DODGE 48RE VALVEBODY HYDRAULIC DIFFERENCES

46RE /47RE TRANSFER AND SPACER PLATE "LOWER-SIDE"

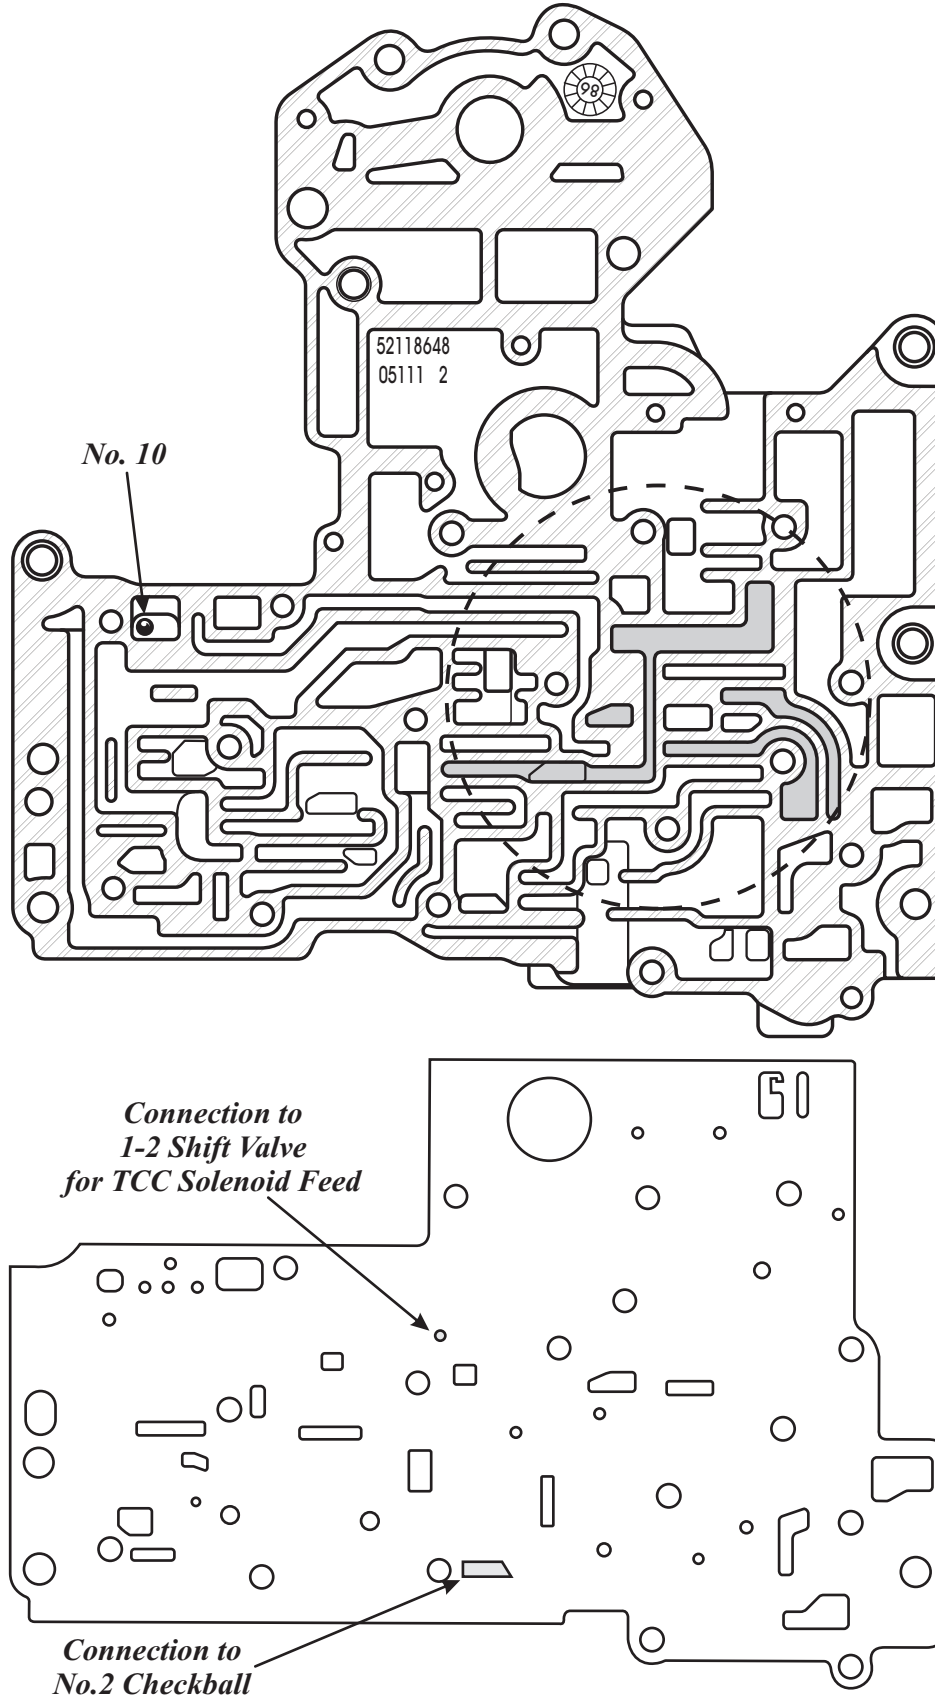
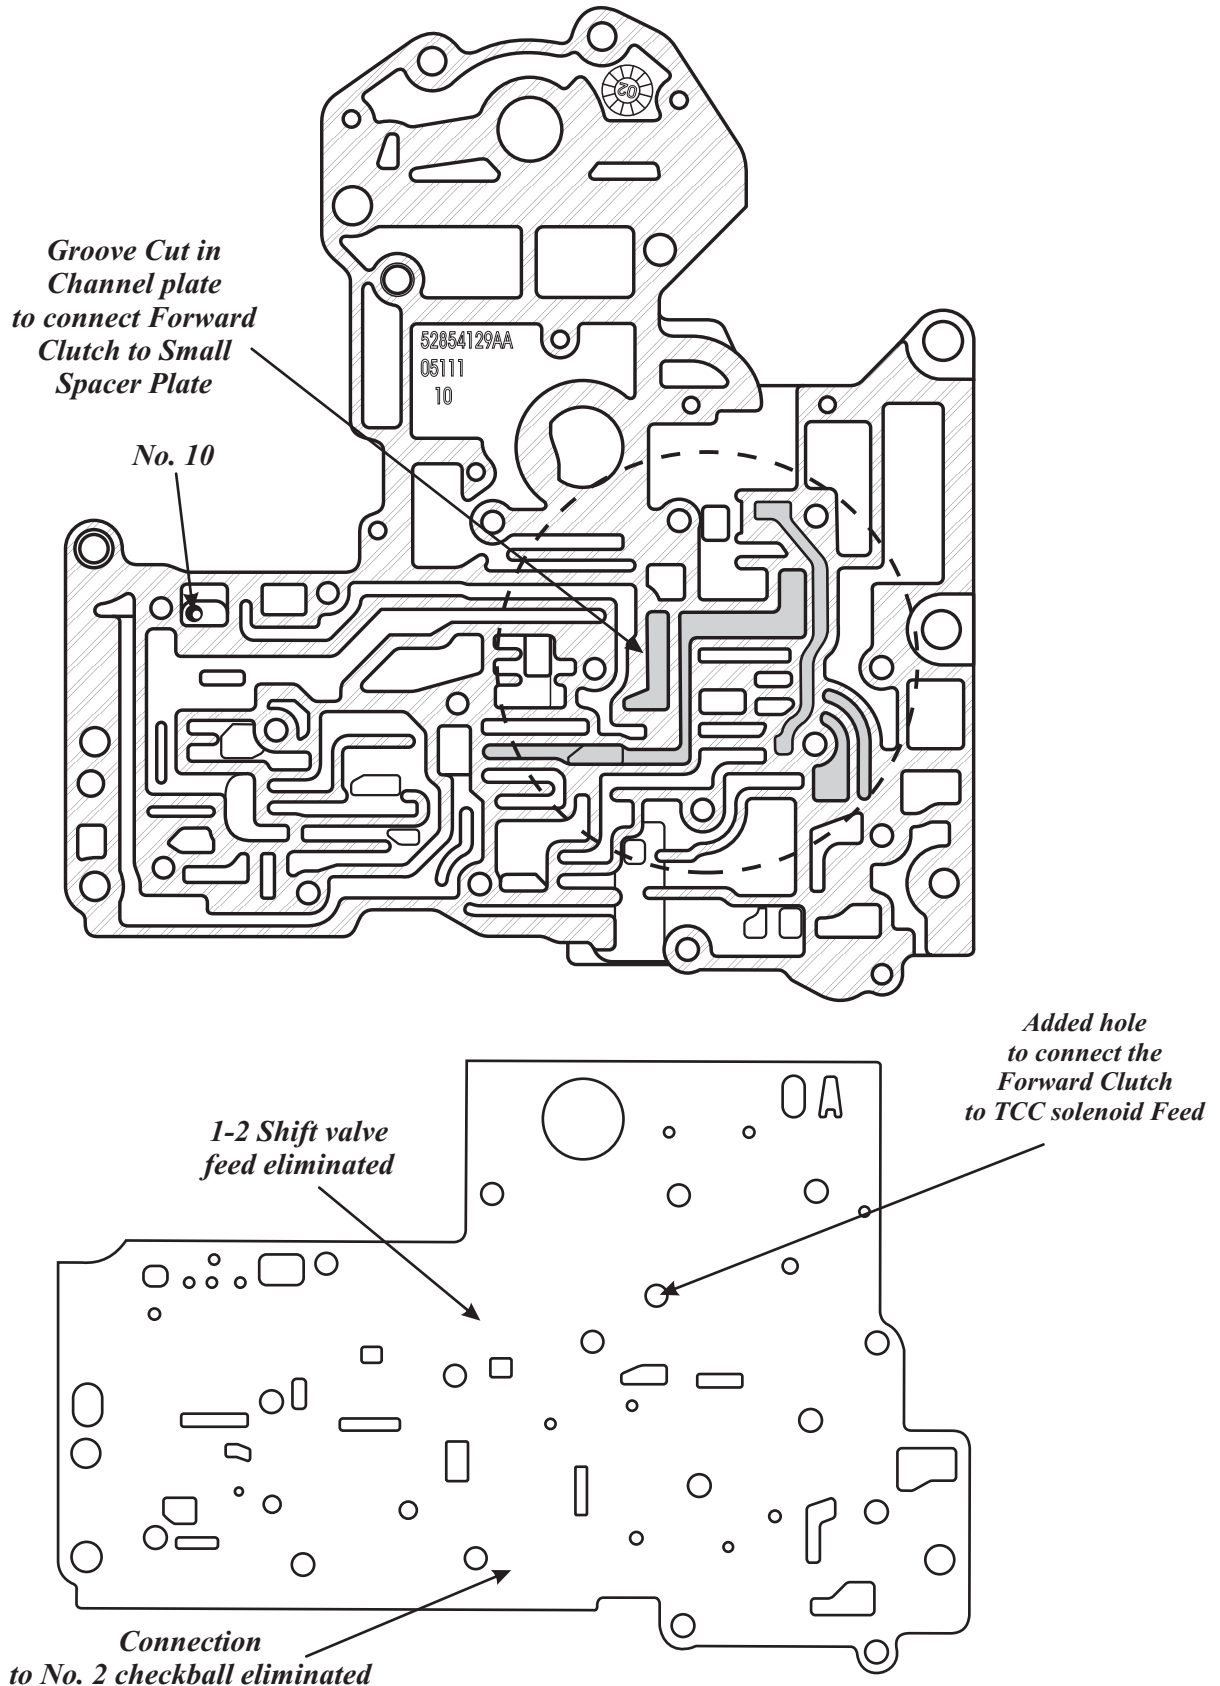
Refer to Figure 5 for a view of the Lower Transfer Plate and Lower Spacer Plate on the 46RE/47RE, and the hole configuration for the Number 2 checkball to the spring side of the Lock-up and 3-4 Shift Valve, and second land of the Lock-up Timing Valve. Also Figure 5 shows the Previous design TCC solenoid feed from the 1-2 shift valve.

Refer to Figure 8 for a view of the Lower Transfer Plate and Lower Spacer Plate on the 48RE, and the hole configuration for the Number 2 checkball is eliminated. Also Figure 8 shows the Previous design TCC solenoid feed from the 1-2 shift valve has been eliminated and the new hole connects the slot in the channel plate to the Forward Clutch circuit.
